# CITY PLAN COMMISSION STAFF REPORT

**CD-CPC-2026-00064**

## 11530 NW Prairie View Road Development Plan

**June 17, 2026**

True Parkings Covered Structures

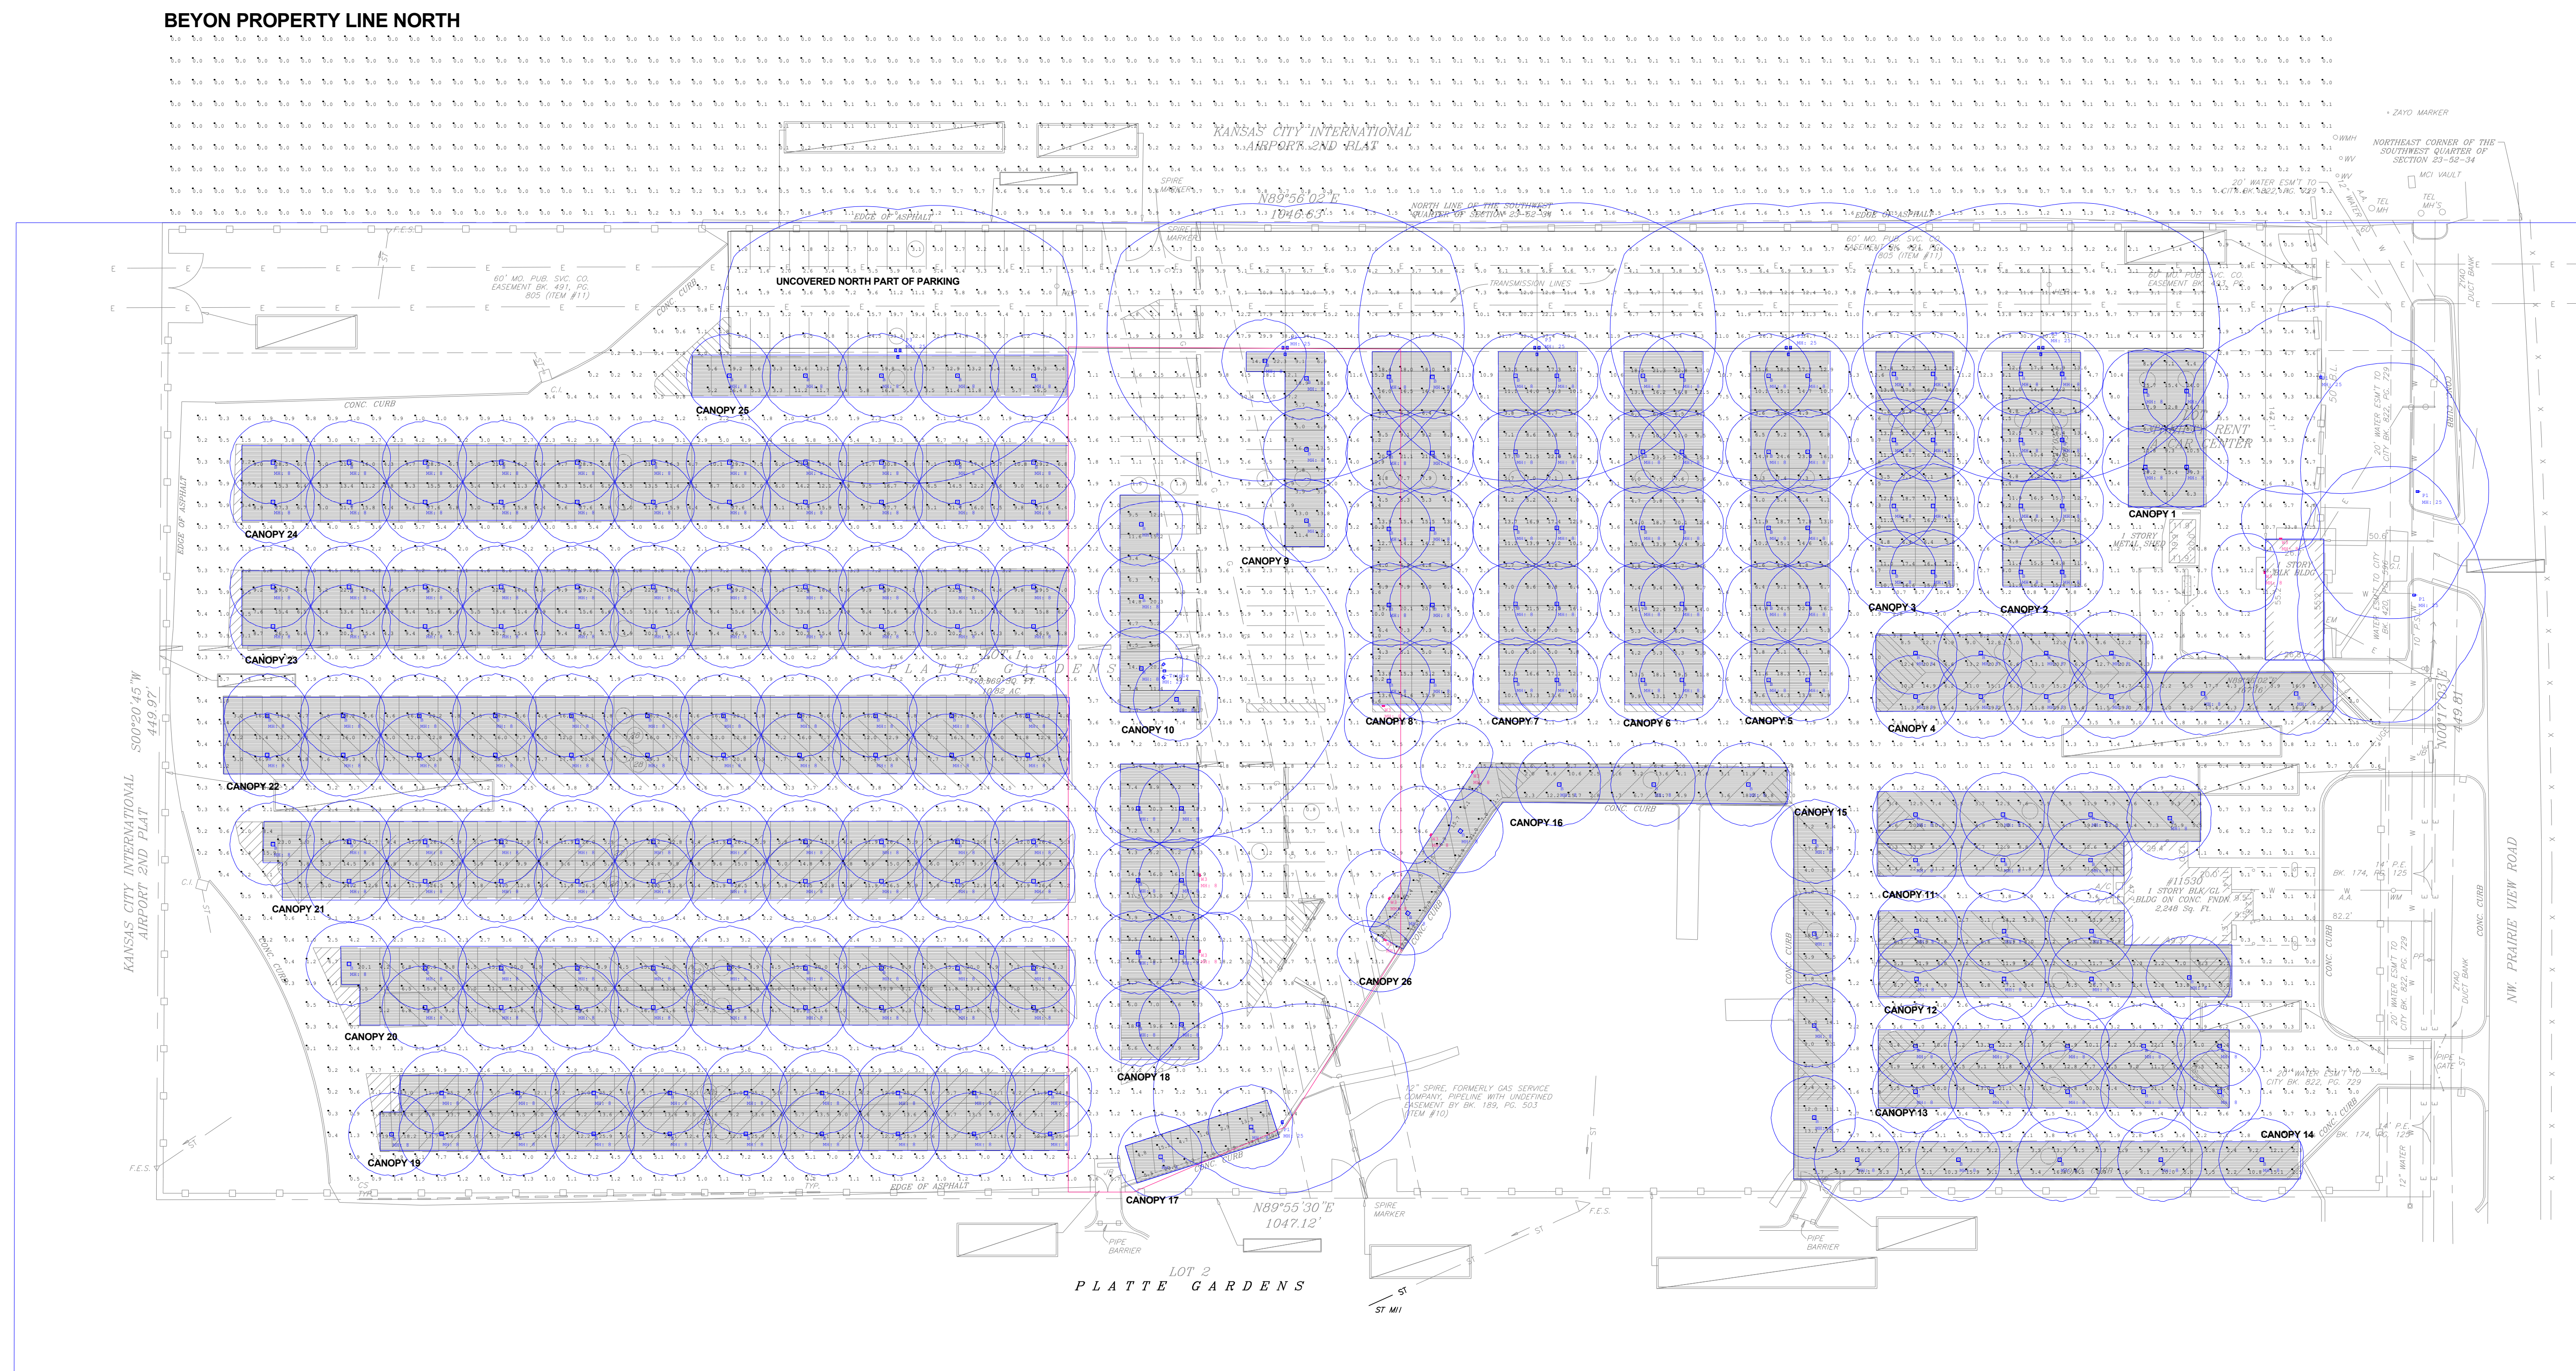
10. After discussion with property owner- prior to obtaining final plan approval, the lighting plan at a minimum shall show a lighting increase in the area between Canopy 8, 9, 10, 17, 18, 26 and near the east side vehicle entry/exit points where the lighting levels are 0fc-.10fc. Development Management Division reviewer may satisfy this condition.
